[Docket No. FAA-2022-1304; Project Identifier AD-2022-00347-T; Amendment 39-22482; AD 2023-12-23]

Airworthiness Directives; The Boeing Company Airplanes

ACTION: Final rule.

Figure 1 to paragraph (i): *Flight deck occupancy (freighter airplane)*

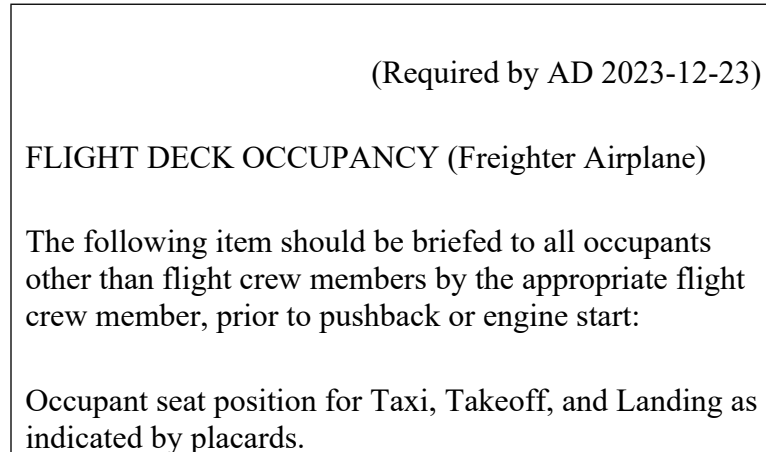
(i) Revision of Existing Airplane Flight Manual (AFM)

Within 12 months after the effective date of this AD, revise Section 3.1 of the

Normal Procedures Section of the existing AFM to include the information in figure 1 to paragraph (i) of this AD. This may be done by inserting a copy of figure 1 to paragraph (i) of this AD into the existing AFM.
